ADDENDUM NO. 4

TO: PLANS AND SPECIFICATIONS FOR STATE OF MISSOURI

Renovate Mechanical / Electrical / Life-Safety / State Office Building
Jefferson State Office Building
205 Jefferson Street
Jefferson City, MO 65101
PROJECT NO. O1911-01

SHEET NUMBER:
S1.2
80 OF 234 SHEETS

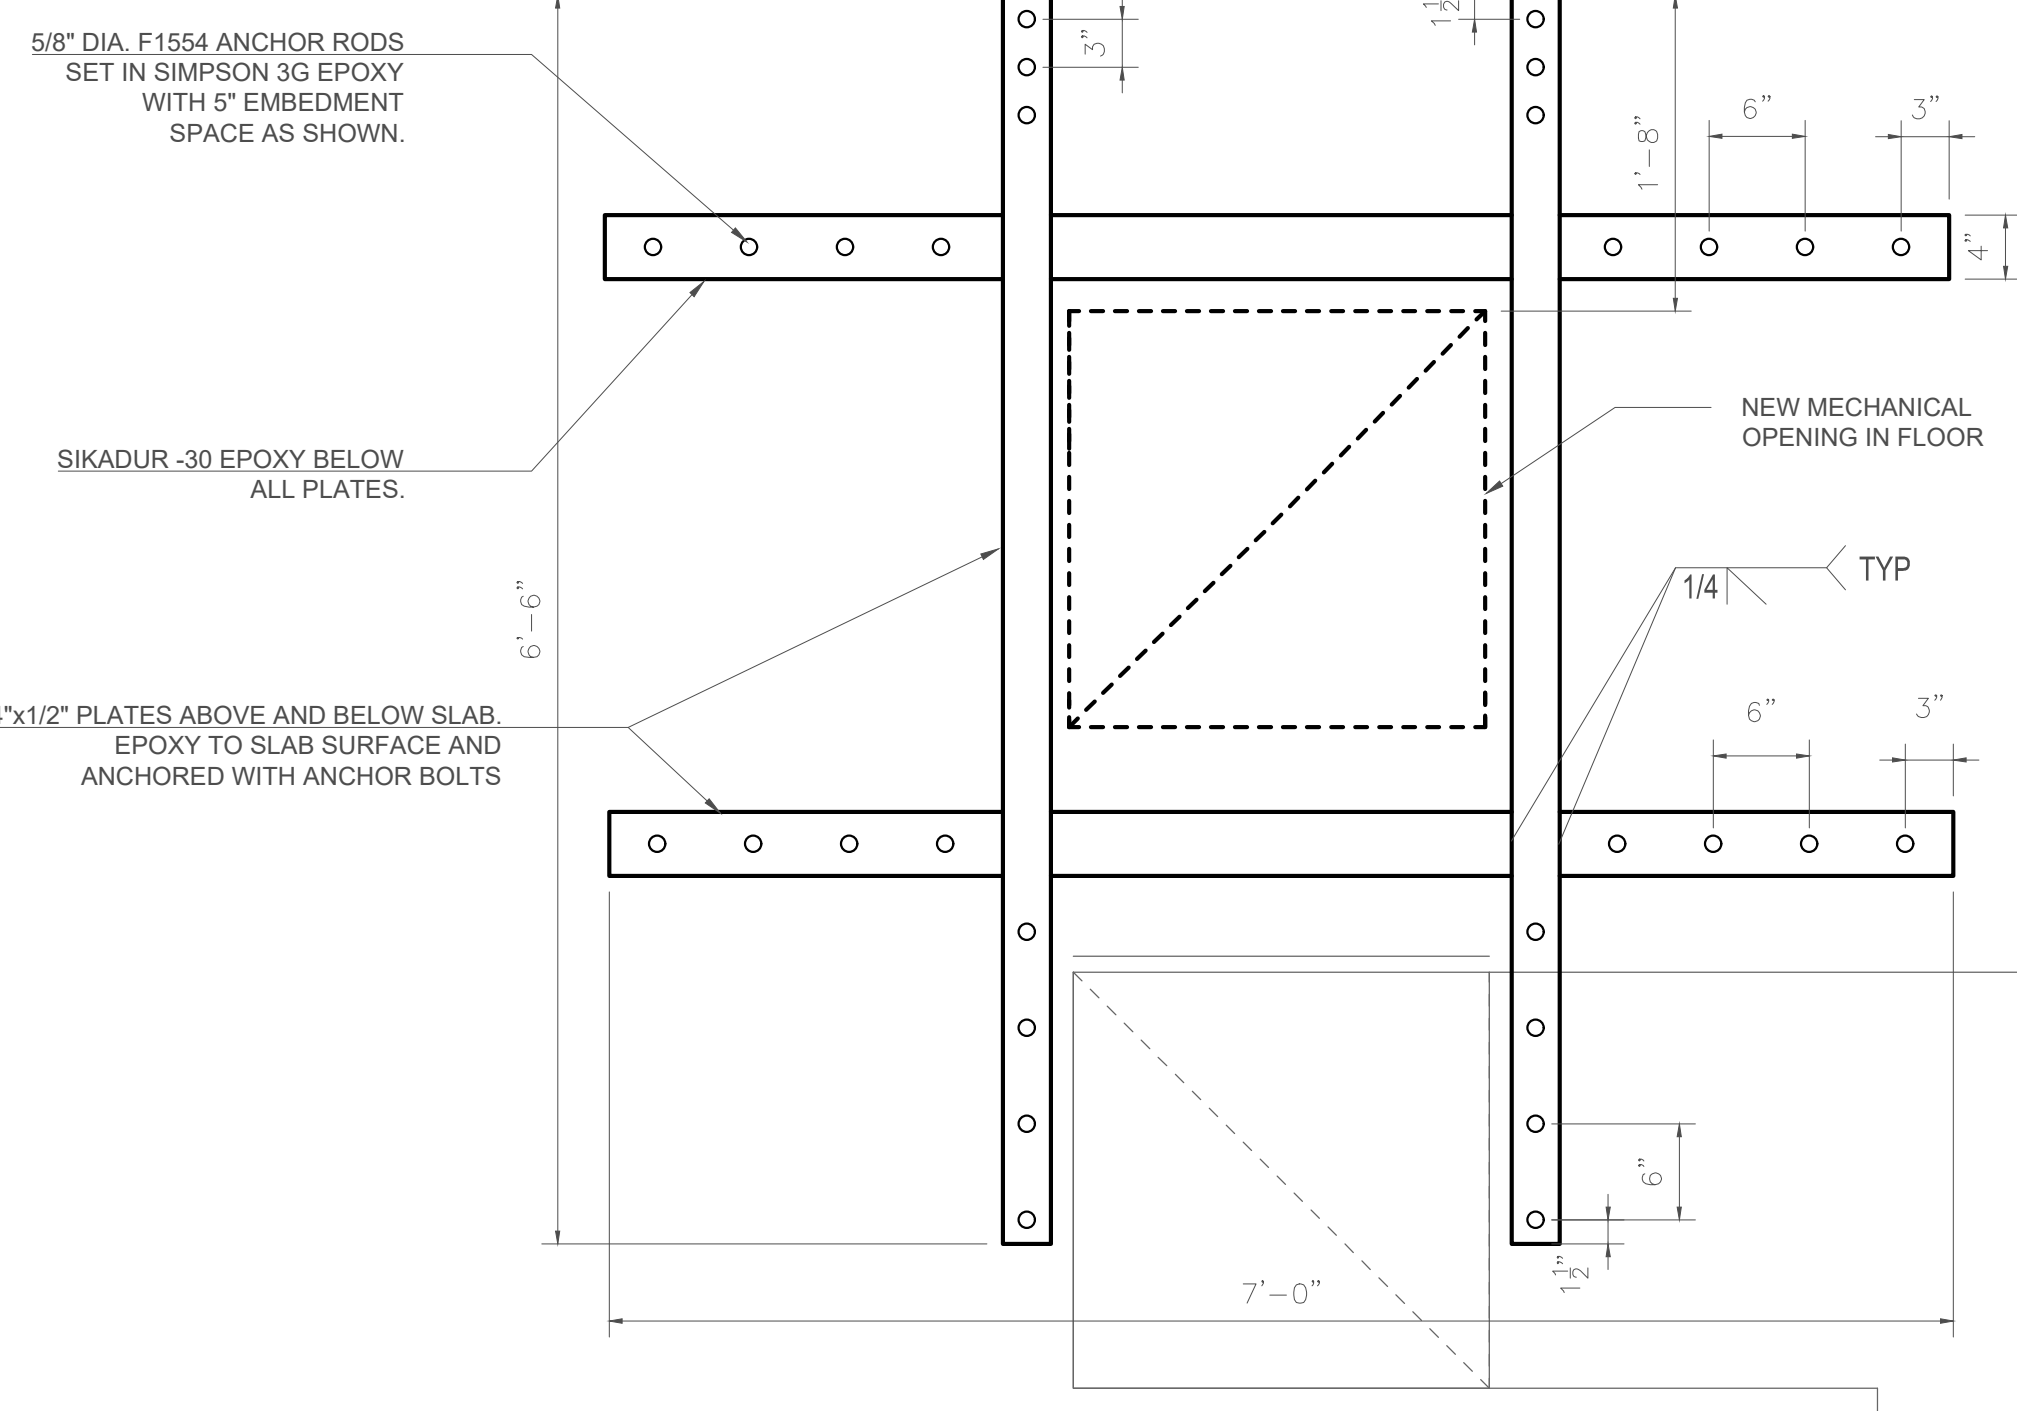
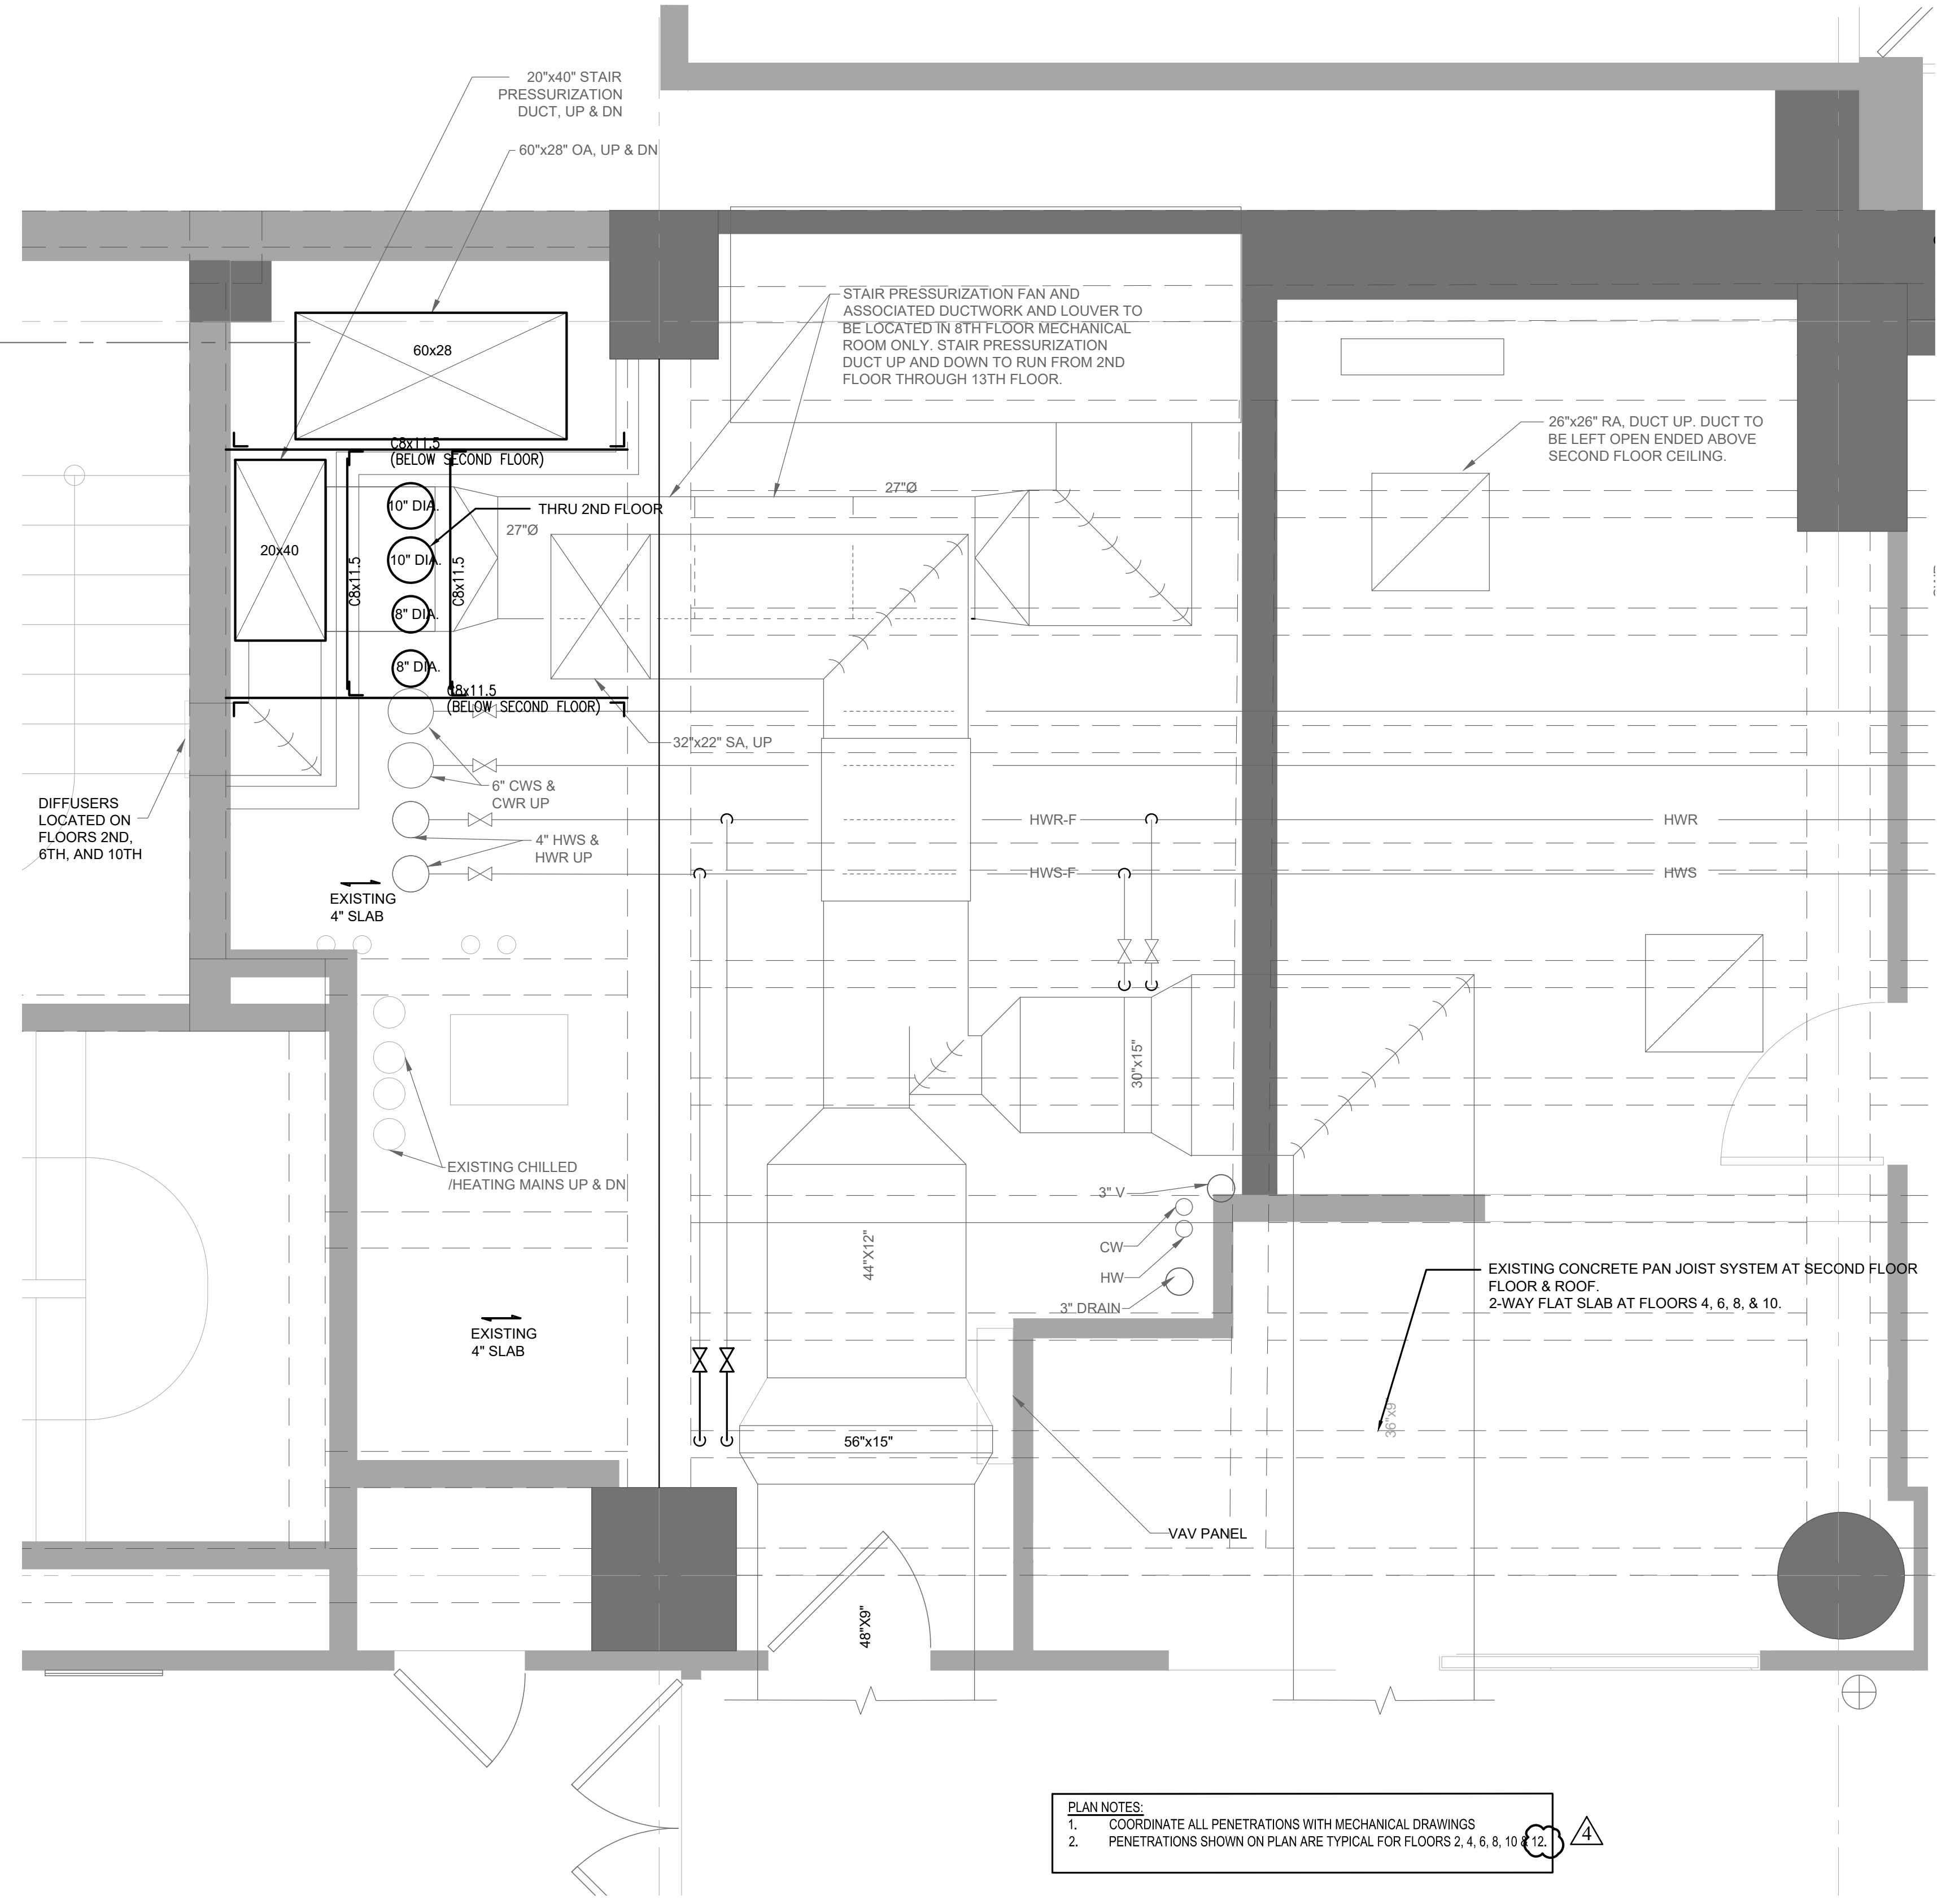
- r. Scale on structure drawing S1.2 is shown as 1/4" = 1.0'. It should be 1/2" = 1.0'.

- s. Third floor plan 2/S1.2 applies to 3rd,5th,7th,9th,11th&13th floors.

- t. Second floor plan 1/S1.2 applies to 2nd,4th,6th,8th,10th & 12th floors.

Response: **UPDATED** Sheet S1.2 to show correct scales.

Response: **UPDATED** drawing 2/S1.2 to show correct floors.

Response: **UPDATED** drawing 1/S1.2 to show correct floors.

M3.0

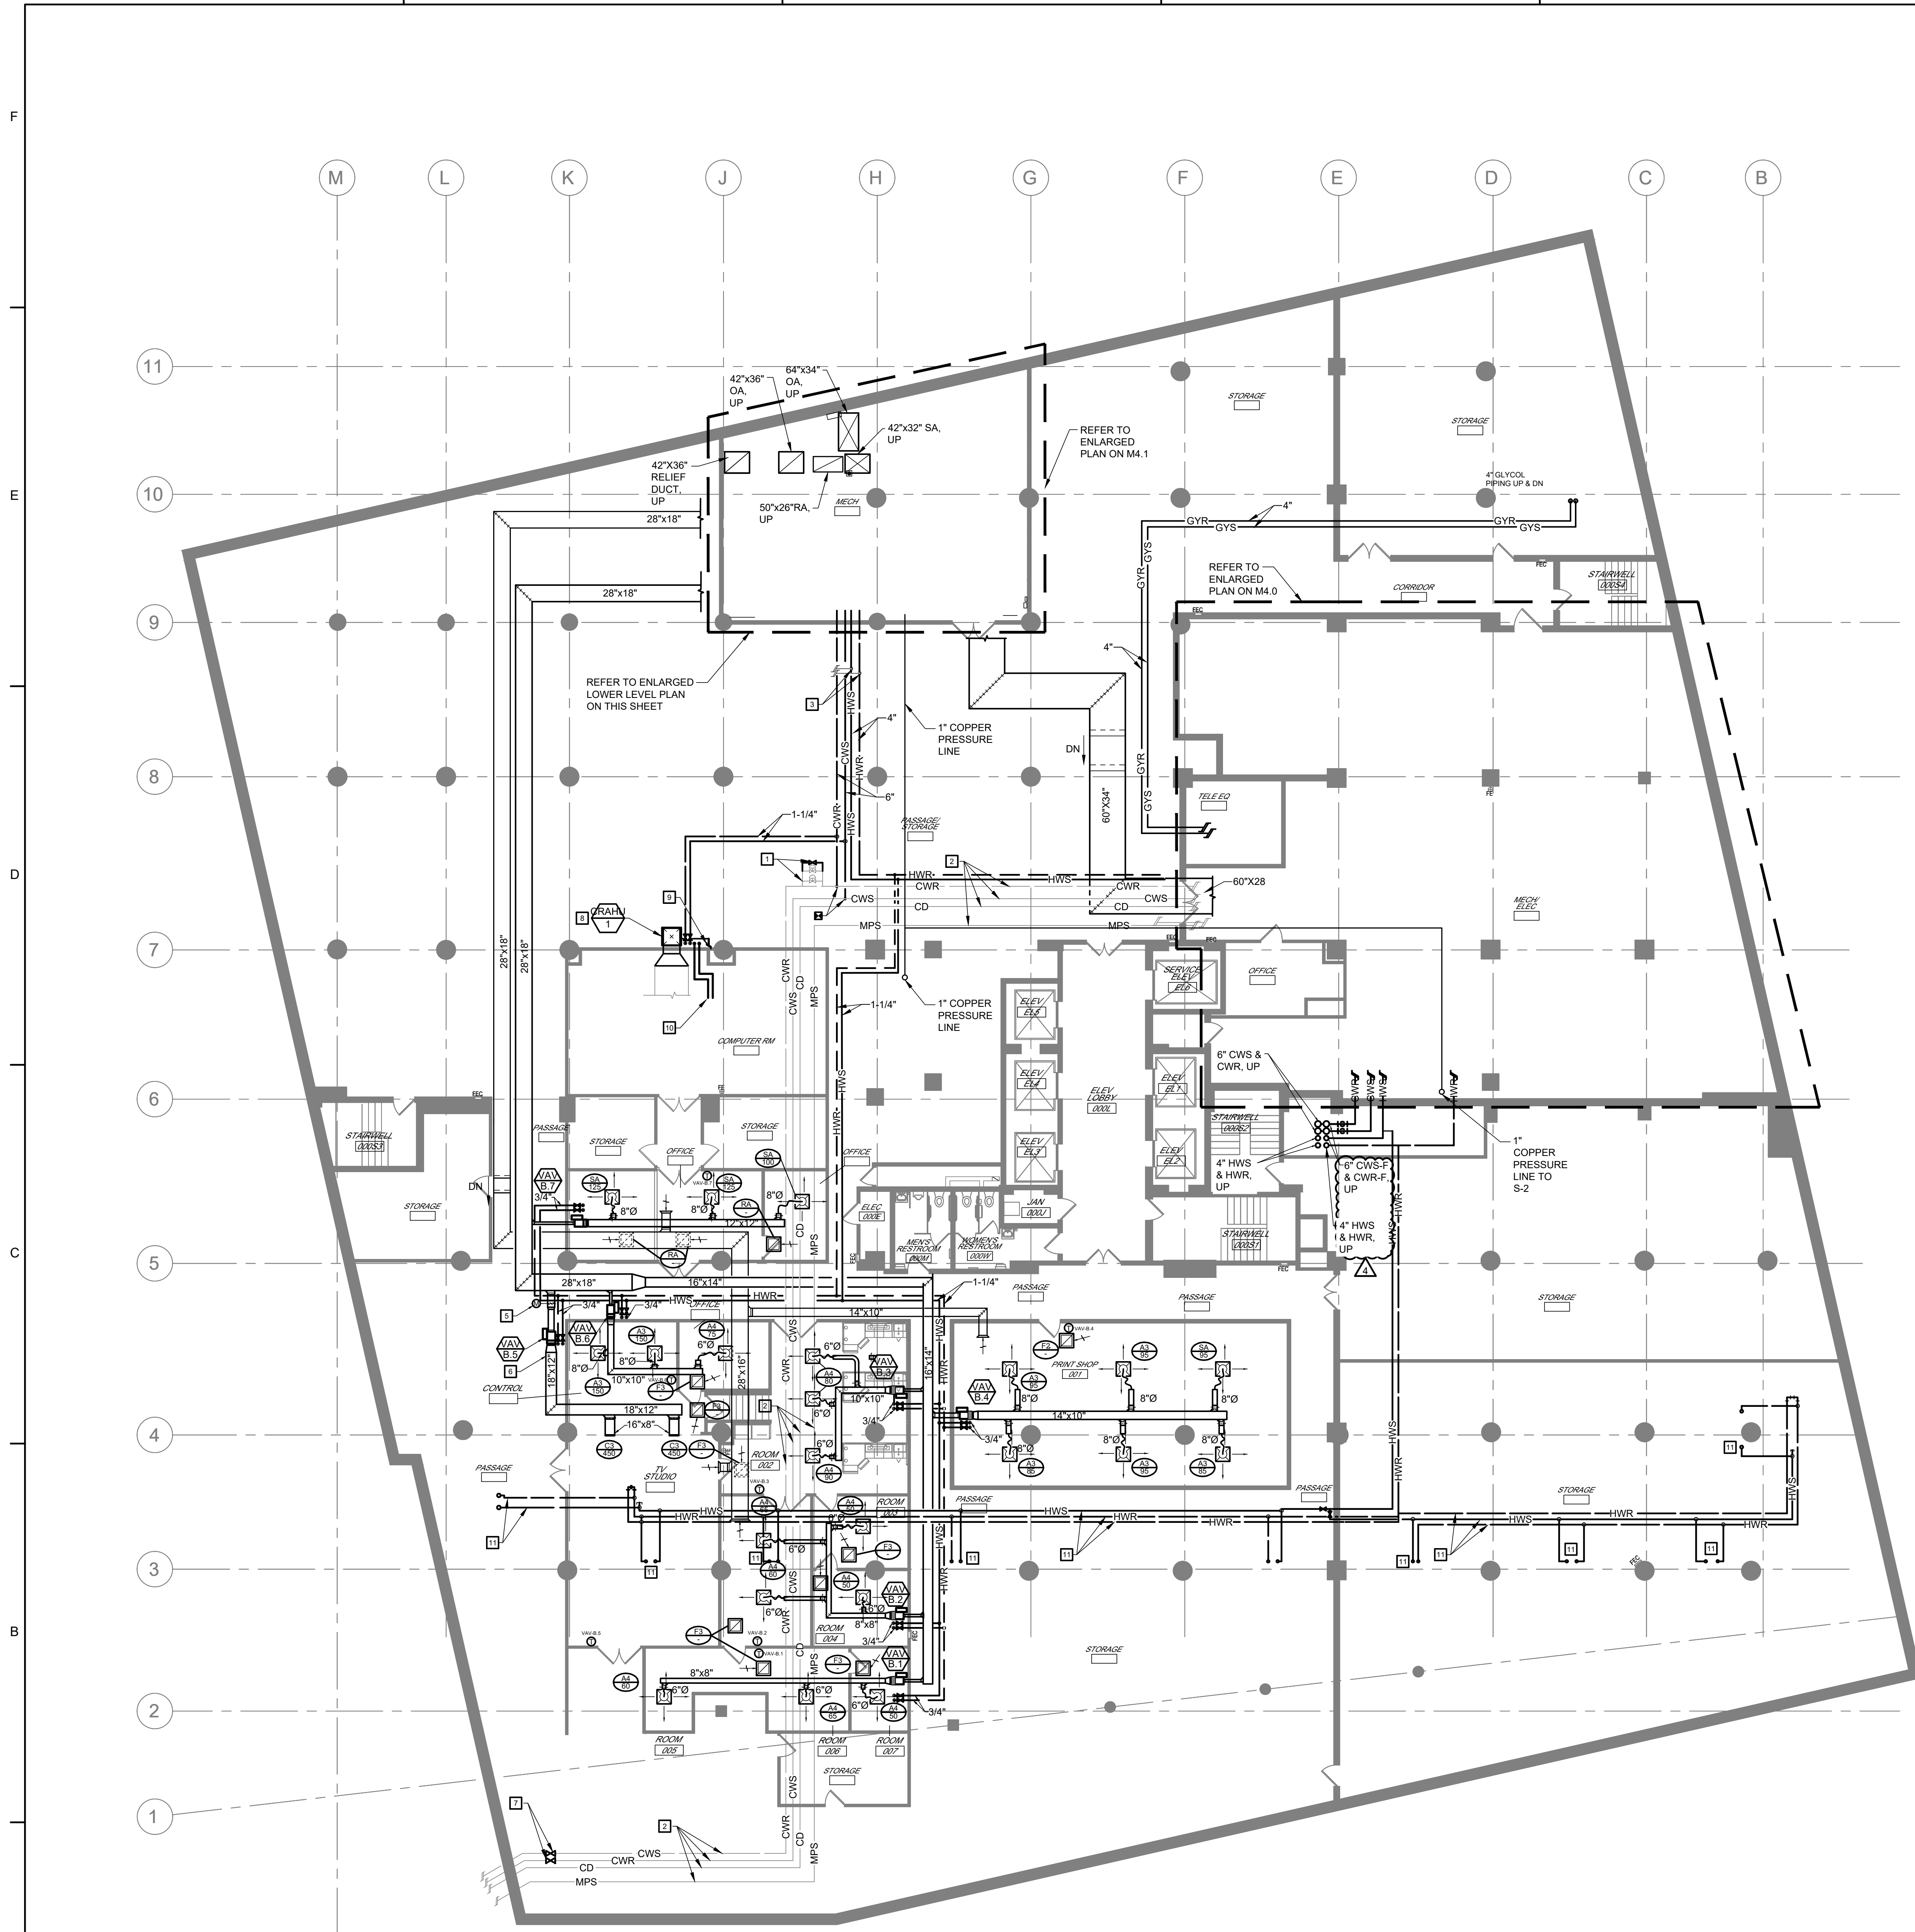
8. Drawing M3.0:
 - a. **UPDATED** – to show correct pipe size.
 9. Drawing M3.1:
 - a. **ADDED** – Piping to FCU-C.
 - b. Clarified Riser Size.
 10. Drawing M3.1A:

- h. "In looking at sheet M4.0, enlarged basement mechanical room, the size callouts for the HHW show the main supply lines to be 4", however when looking at the flow diagram on M5.0, those supply/return lines should be 6". Which size do you want used?

Response: See updated sheets M4.0, M3.0 & M5.1
- Separately, on the chilled water lines, sheet M3.0 shows 2 risers coming out of the basement mechanical room (roughly located at gridline intersection E6. On M3.0, fan coil riser is called out to be 8" line but when referencing M4.0, the enlarged detail shows those risers to be 6". Which size is correct?"
